18 January 2024

Our ref: NFR/SNE/HDA/FPL/U0013257

Your ref: 2023/3870/P and 2023/3901/L

Brunswick Centre, London, WC1N 1AE
Application for Full Planning Permission and Listed Building Consent
Response Letter to Technical Consultation Comments

THERMAL MODELLING RESULTS

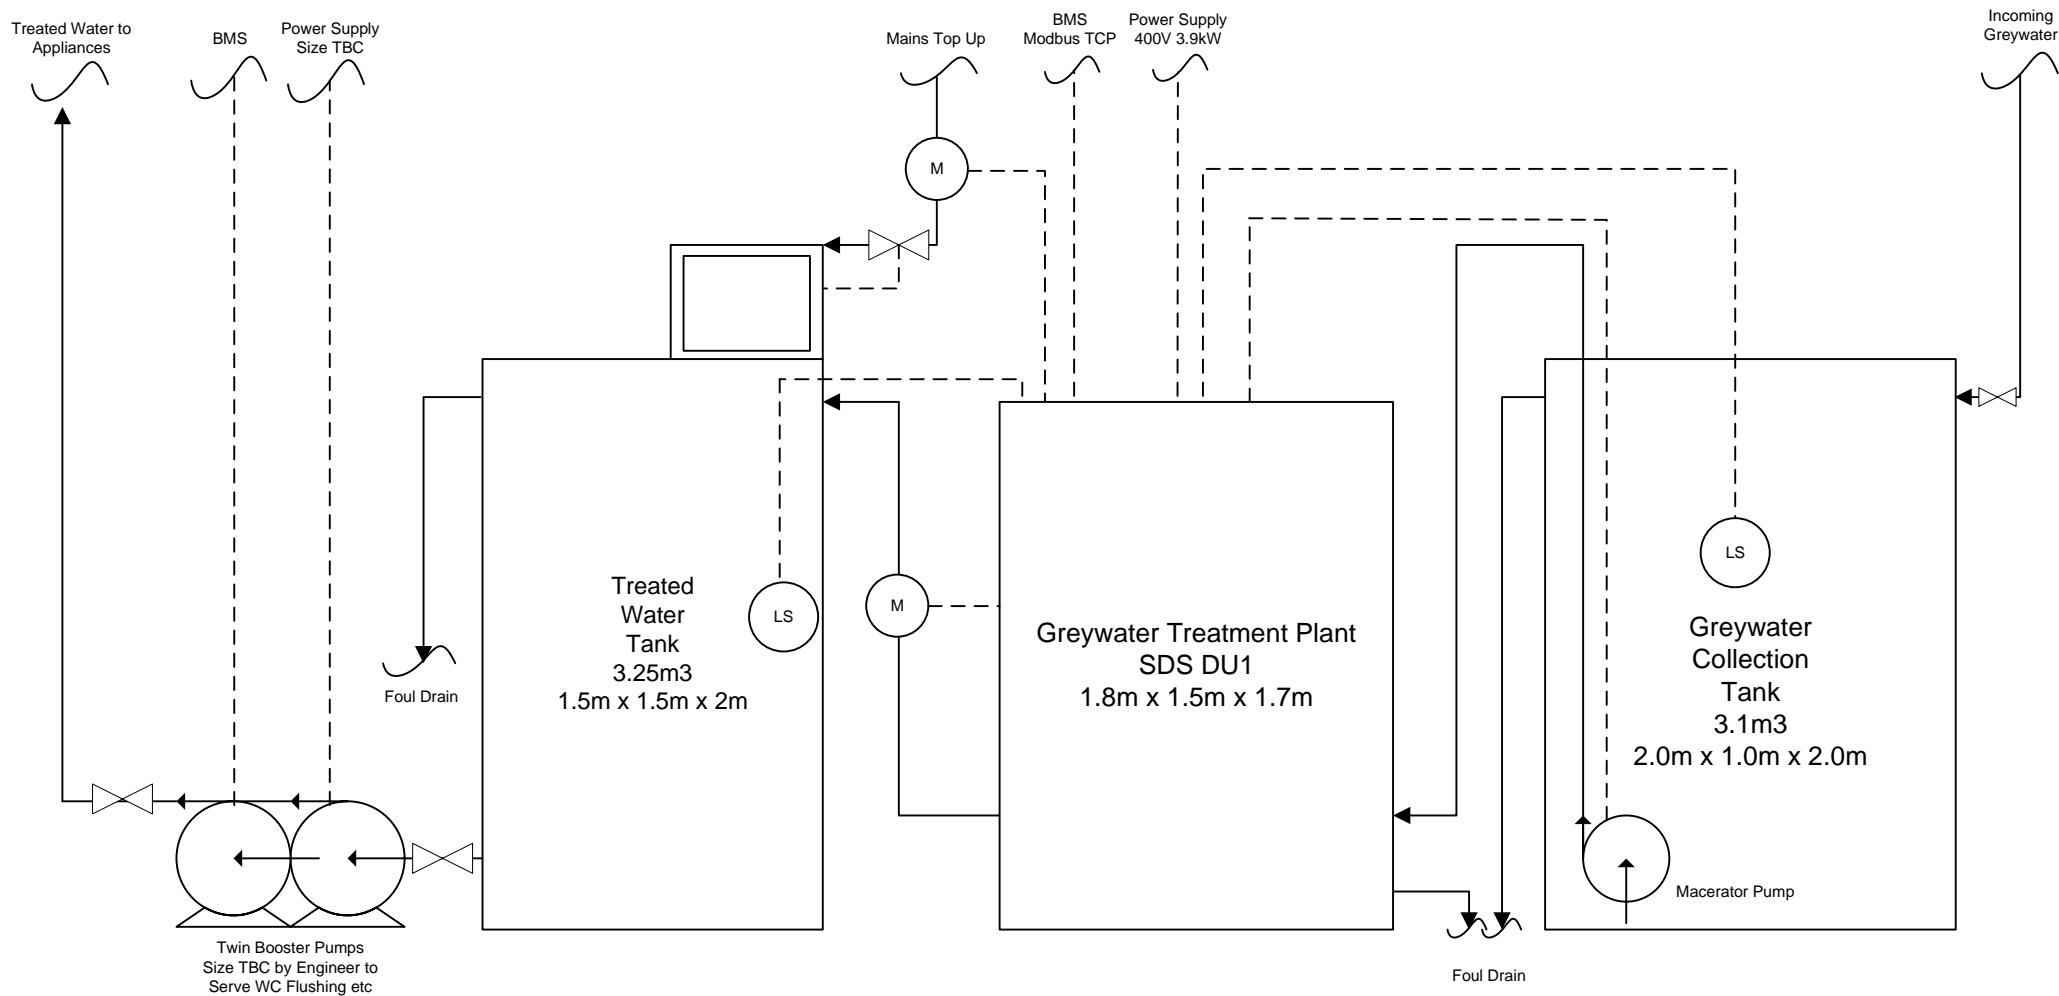
6. *Active cooling must be proven to be necessary where it is introduced in any development. Due to the subterranean nature of the development, it may not be feasible to have natural ventilation but it should be shown that active cooling is necessary beyond simply having mechanical ventilation without cooling – as outlined in Camden’s Local Plan and Planning Policy Guidance Dynamic Thermal Modelling should be undertaken to demonstrate the necessity of cooling.*

The results show that it would not be possible to obtain adequate comfort levels as per TM52 and CIBSE Guide A standards through the mechanical ventilation system only, even if the ventilation rate is increased beyond the normal ventilation requirements. TM52 requires for mechanically ventilated buildings that the operative temperature does not exceed 26°C for more than 3% of occupied hours. Whereas CIBSE Guide A recommends operative temperatures to be maintained within a specific range depending on the building and room type, as well as the Predicted Mean Vote (PMV) within the ± 0.50 range.

Client	Whitbread Group plc				
Project	Brunswick Centre				
Drawing Title	Swept Path Analysis				
Drawing No.	2020/5262/001			Rev.	P3
Scale	As shown	Drawn By	DLH	Checked By	NDR
					A3

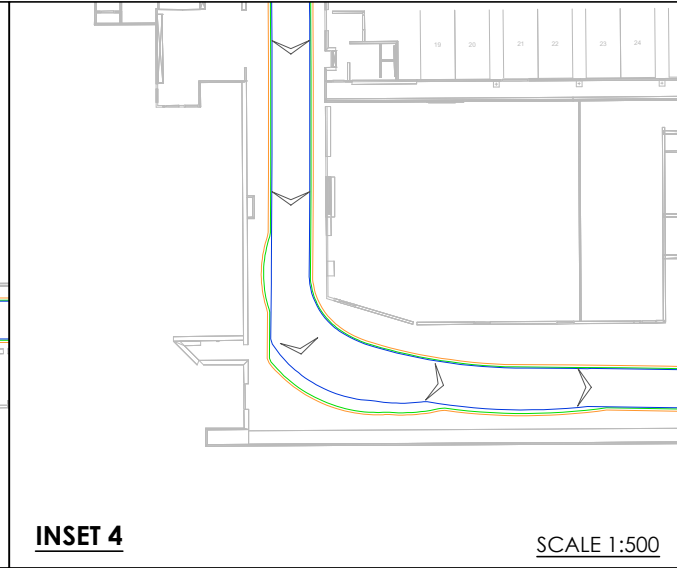
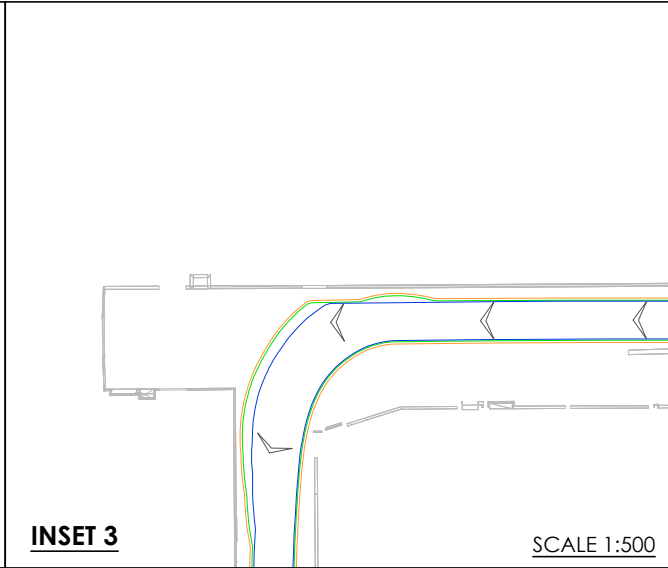
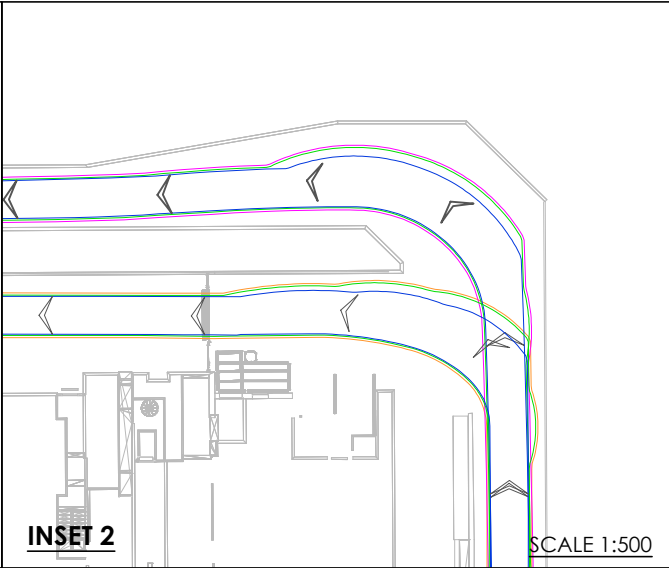
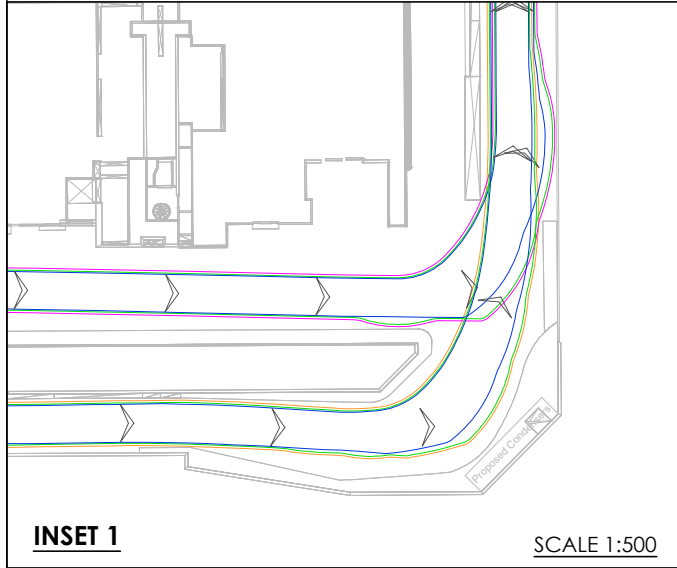
Officers further requested an additional plan in relation to servicing, which is appended to this response letter at Appendix E.
